# Highland Lakes Elementary Proposed BMP Improvements

Project: Highland Lakes ES Drive Lane Pond Improvements

We've prepared the following summary of LCRA Water Quality BMP Improvements that have been required for previous and current development on the Highland Lakes Elementary School Site. Note that current LCRA requirements significantly exceed BMP designs provided for previous development on the site. Refer to Attachments A-C for plans previously approved by LCRA. During review of the currently proposed site improvements, LCRA also required additional levels of design detail with direct cost implications. Refer to Attachments D-F for design progression through LCRA review. Refer to Attachment G for LCRA Comment Response Letters. Refer to Attachment H for Additional Required LCRA Permit Documentation. Some requests from LCRA, including an underdrain system in Pond 2, were waived through coordination during site review.

**Attachment G: LCRA Comment Response Letters**

# ATTACHMENT F

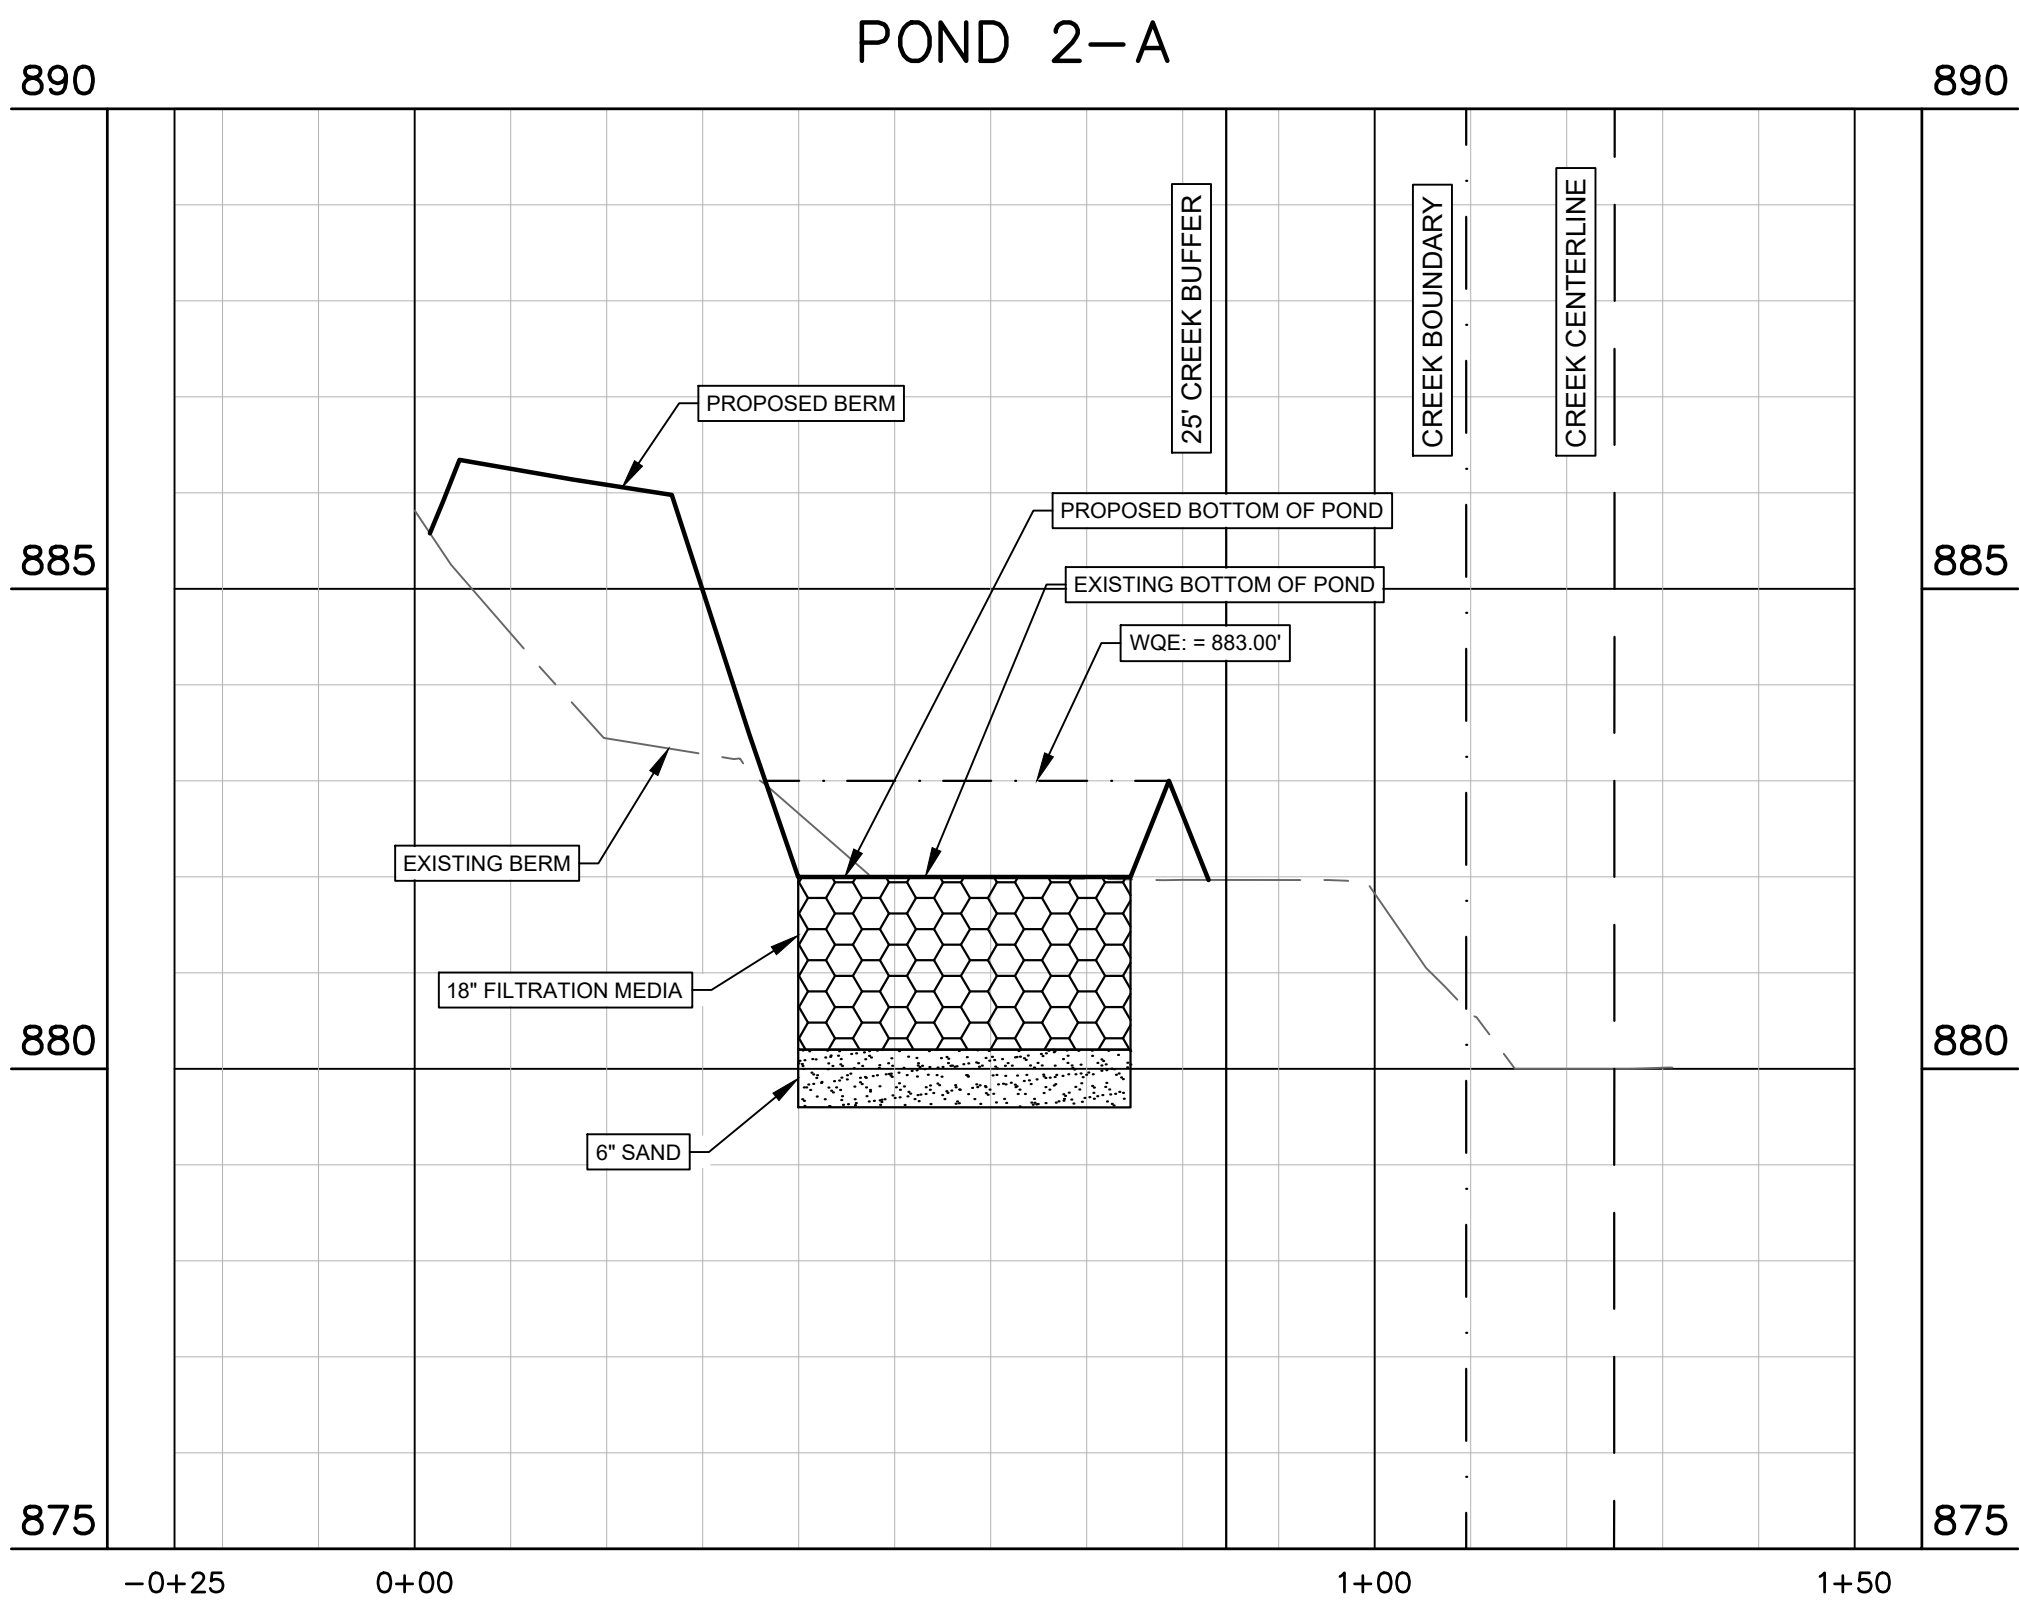
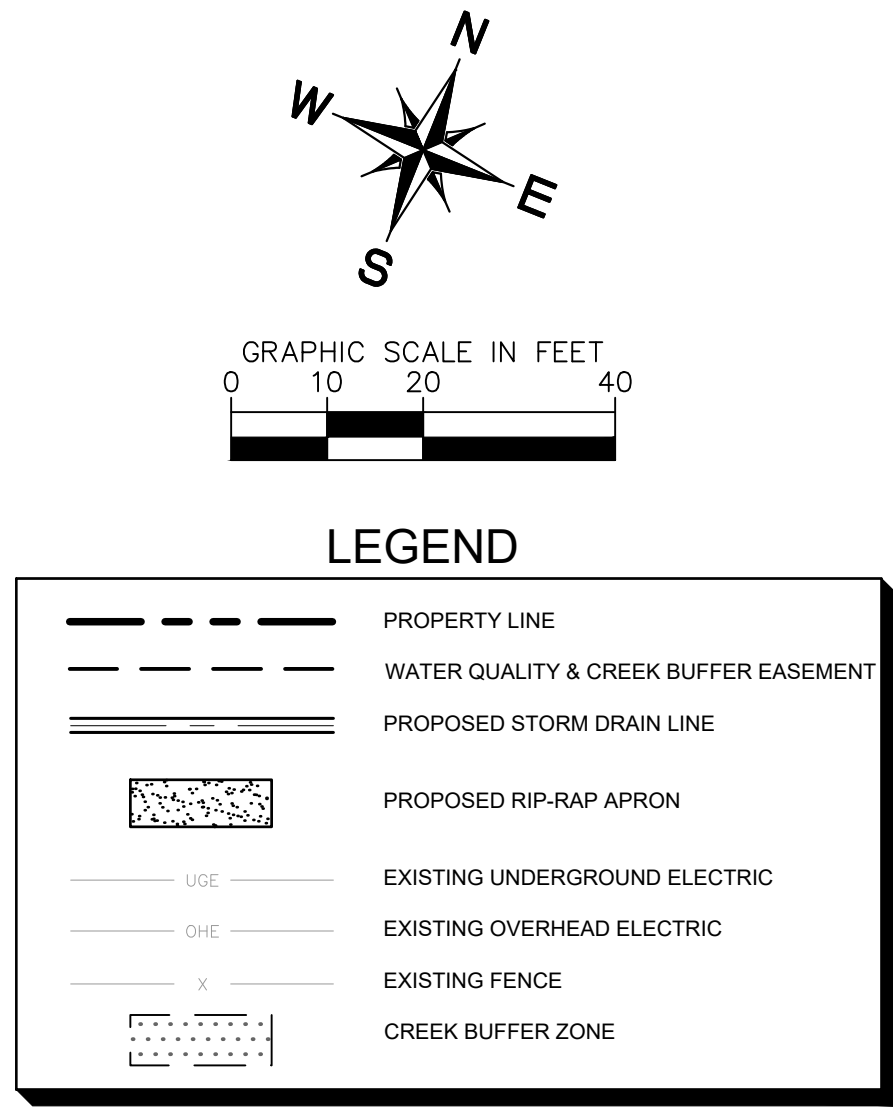
U2 – Comment partially addressed. Please adjust or provide the following for Pond 2:

8. Current slope on the upstream embankment is over 30% recommend adding riprap on embankment and sizing it to the 25-year flow event to avoid any scouring. Also, please provide calculations.
9. Provide discharge velocities used to size the downstream riprap apron. See comment #33-U1.

8. Rip-rap has been added all along the upper embankment of the pond, similarly to how it's shown on the downstream end. Calculations for the rip-rap sizing and apron length are provided on the Pond 2 Plan & Profile plan sheet. Peak flow and velocity for the 100-YR storm event was used in place of the 25-YR flow to provide the maximum Rip-Rap values needed.

9. The discharge velocity used to size the rip-rap downstream has been included within the rip-rap calculations table on the Pond 2 Plan & Profile plan sheet.
